**March 9, 2021
5:30 P.M.
REGULAR MEETING
AGENDA**

Dear Norwalk Redevelopment Agency Chairman and Commissioners,
At the February 9th meeting of the Norwalk Redevelopment Agency, the Commissioners voted to table the review of 637 West Avenue in order to provide the application with an opportunity to reconsider their proposal to replace the existing portico with a two-story glass atrium. 637 West Avenue is listed on the local Norwalk Historic Resources Inventory List. Its most prominent feature is its existing two-story wood columned pediment, which mimics the design of the old City Hall building on Main Street.

Andriopoulos Design Associates was selected as the 3rd Party Design Reviewer to comment on the compliance of these proposed Façade Improvement with the Wall-West Neighborhood Design Guidelines. ADA previously recommended approving the proposed design for being compliant with the Wall-West Design Guidelines.

D2.01

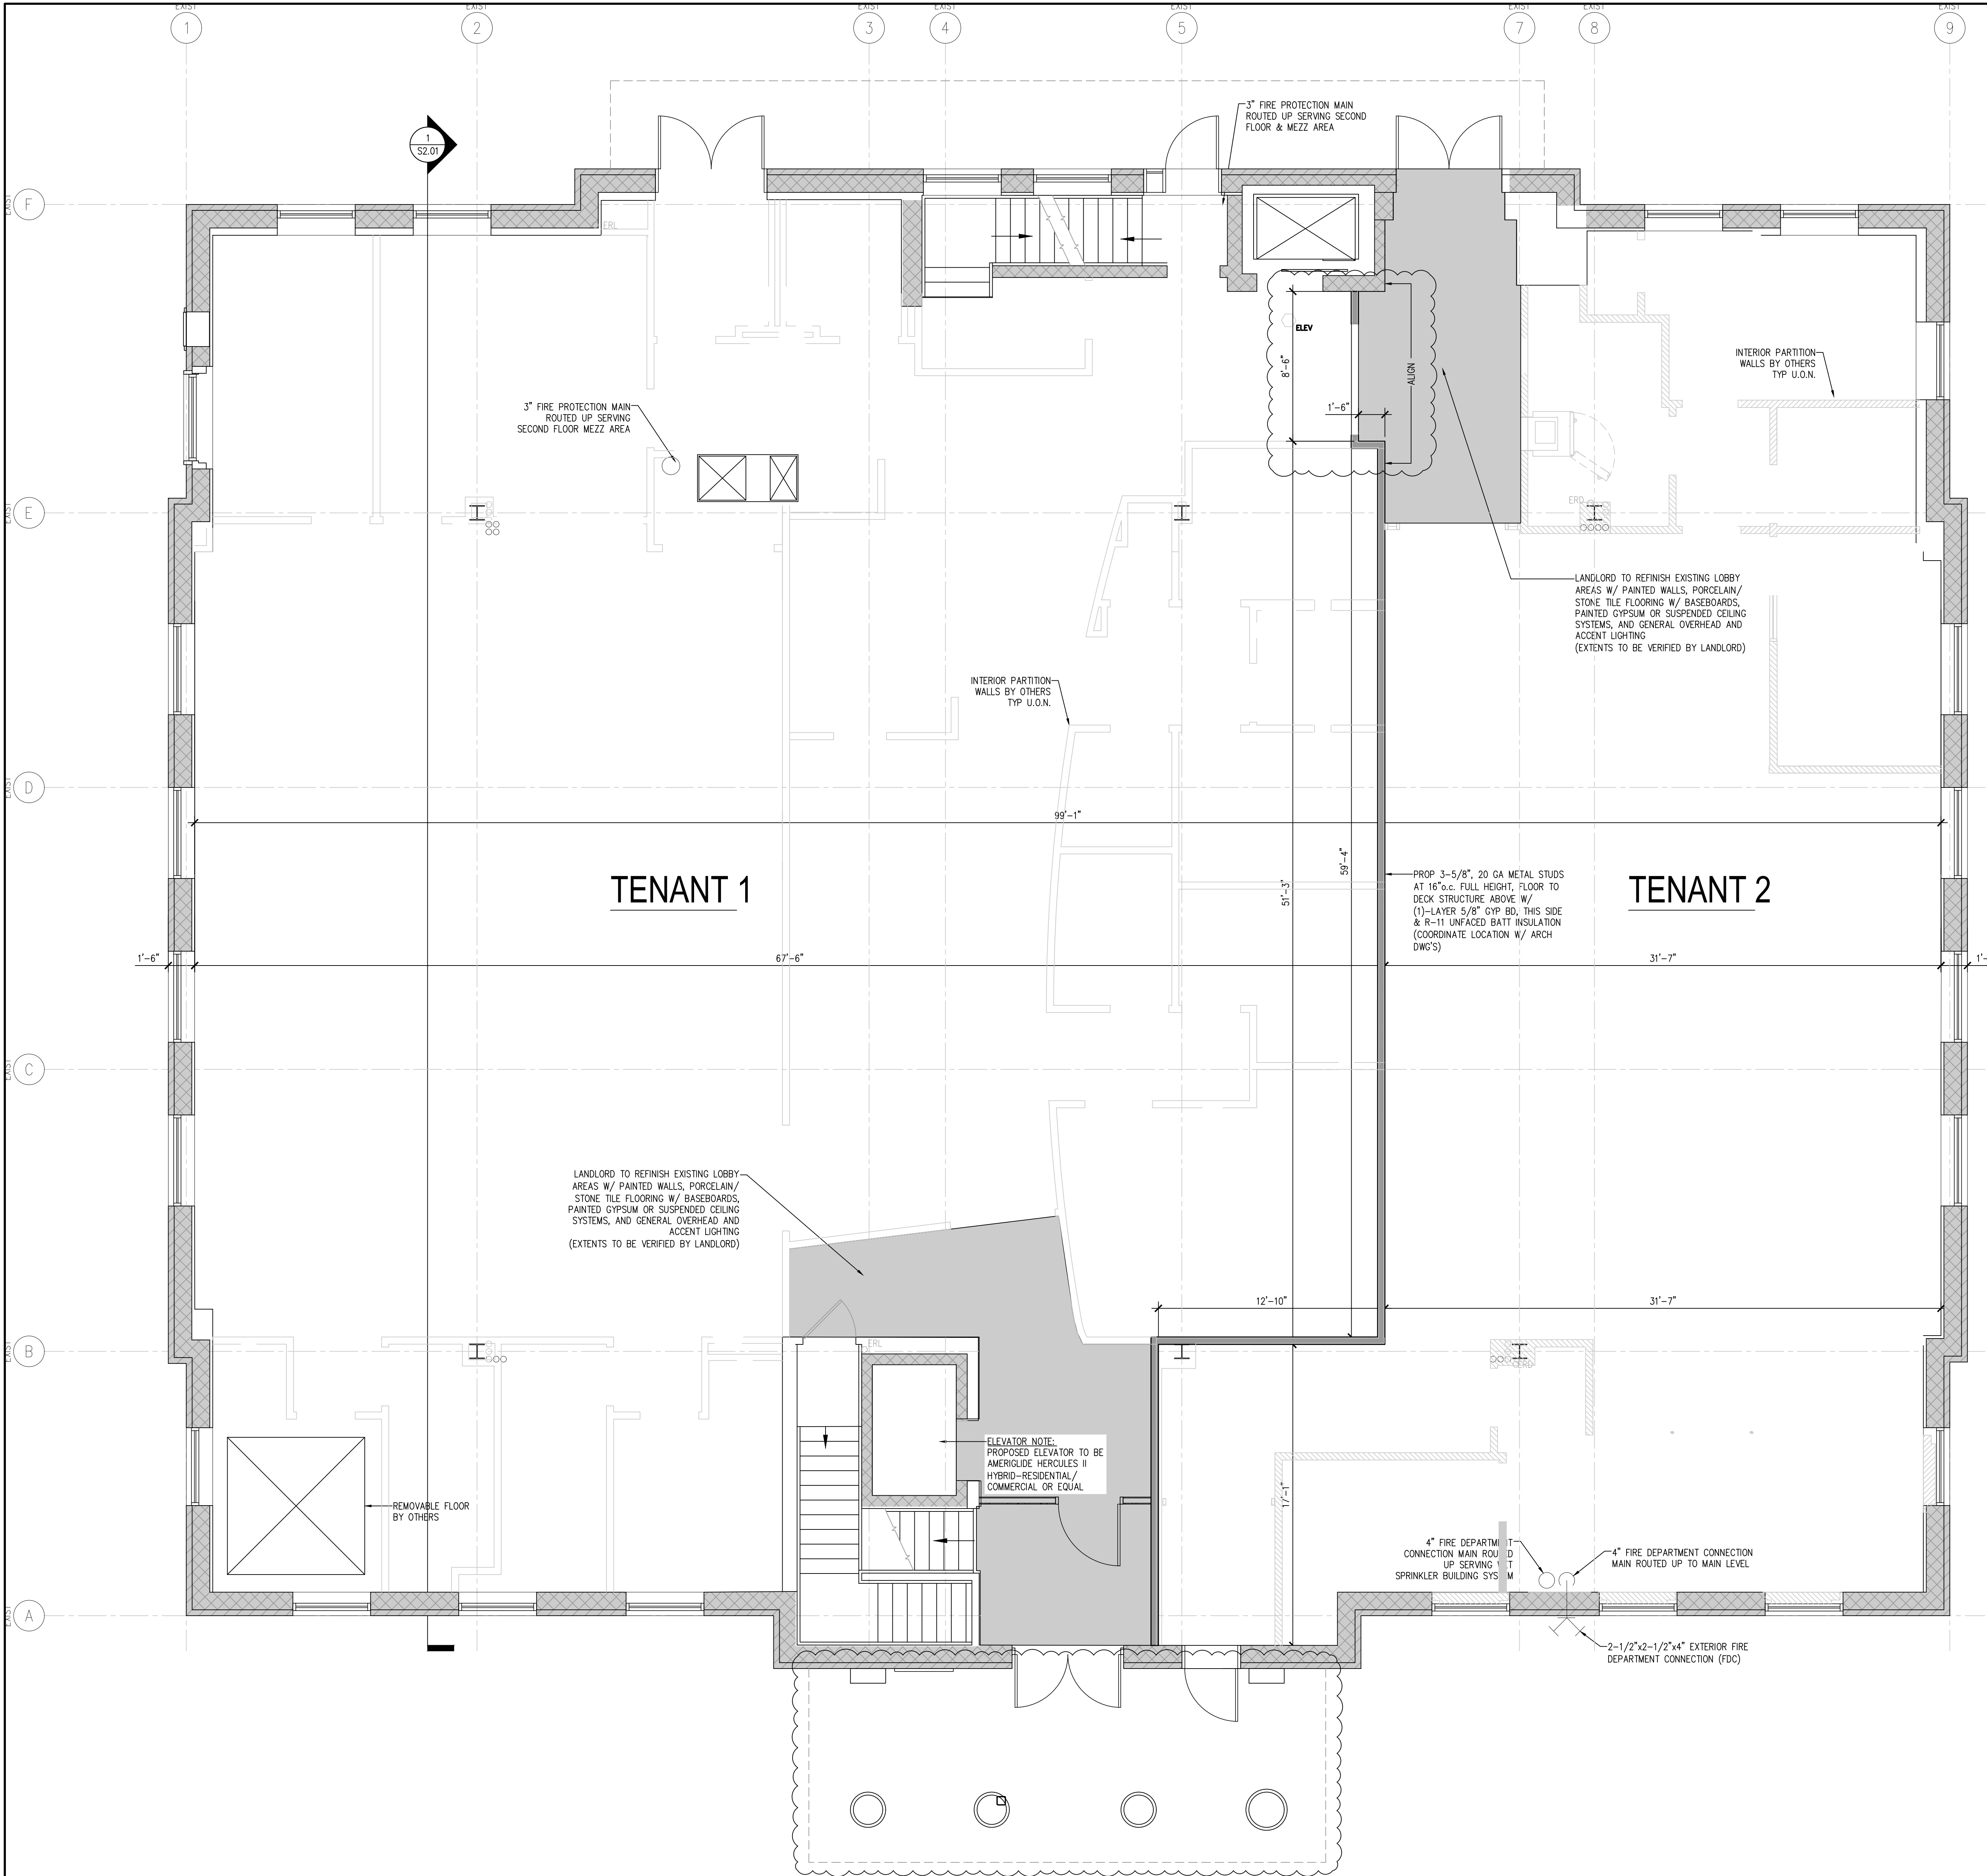
Mr. Westmoreland said that the removal of the front columns was a major change. He felt that the new design was a generic office box as opposed to the current portico and columns, which compliments St. Mary's Church next door. He added that with such a dramatic change, the Board may wish to table this for a month to allow for public comment since he did not think that people were aware of the proposed changes. Discussion followed.

- Retention of the existing front portico;
- New exterior lighting, site paving, and canopies;
- Installation of two new exterior doors on either side of the main entryway;
- Removal of a drive-thru window and rebuilding of the window opening and brick wall;
- Installation of new doors and windows throughout; and
- Creation of a new rooftop mechanical structure.
